# Instrument Panel Rattle

YEAR(S)	MODEL(S)	ADDITIONAL INFORMATION
2006 – 2007	IS250, IS350

### TSB SUPERSESSION NOTICE

The information contained in this TSB supersedes TSB No. NV003–06.

Figure 1.

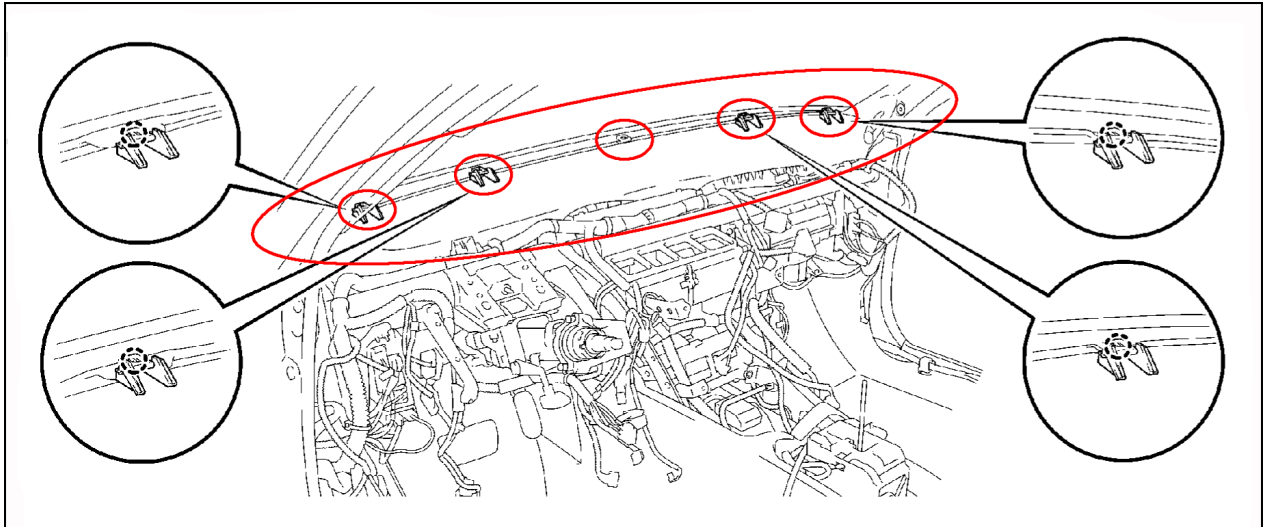
3. Remove the instrument panel clip (Stay No. 3) at the center of the dash and replace with the NEW clip. Repeat the same on the remaining four clips (instrument panel clip No. 1).

**Figure 2.**

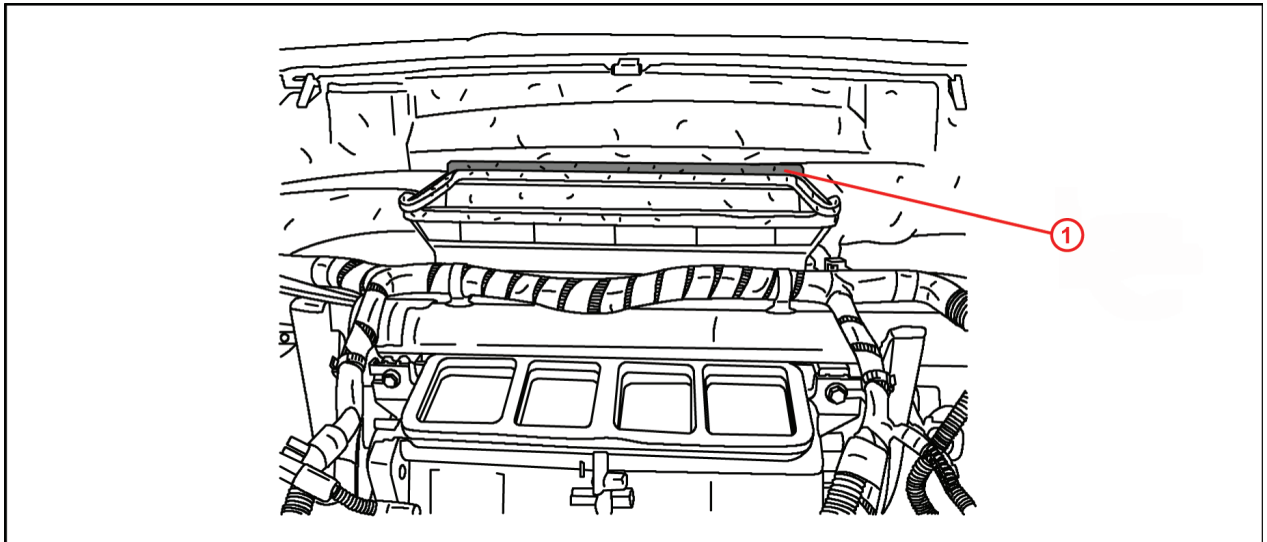
4. Apply felt along the defroster nozzle lip as shown in Figure 2.

<b>1</b>	Apply felt (as necessary) in this area if the urethane foam is worn away or if there is plastic to plastic contact between components.
----------	--

**Felt Size**

**Length:** 29 cm (11.42 in.)

**Width:** 14 mm (0.55 in.)

**Thickness:** 0.5 mm (0.02 in.)

Figure 3.

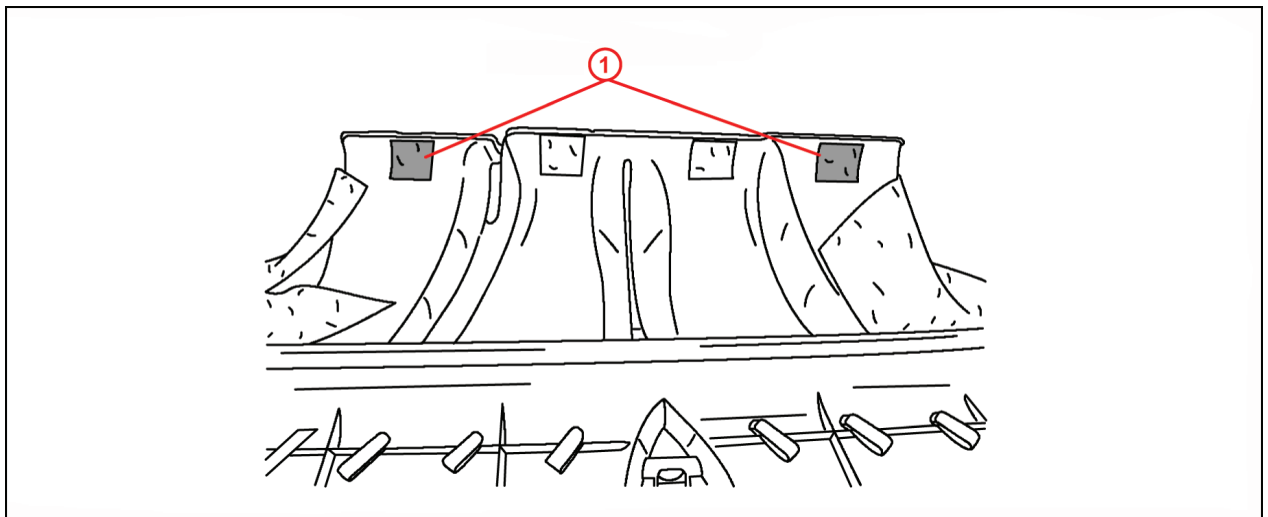
5. Apply foam to the instrument pad HVAC duct as shown in the following illustration.

**1** Apply foam here

**Foam Size:**

**Length:** 30 mm (1.18 in.)

**Width:** 30 mm(1.18 in.)

**Thickness:** 5 mm (0.20 in.)
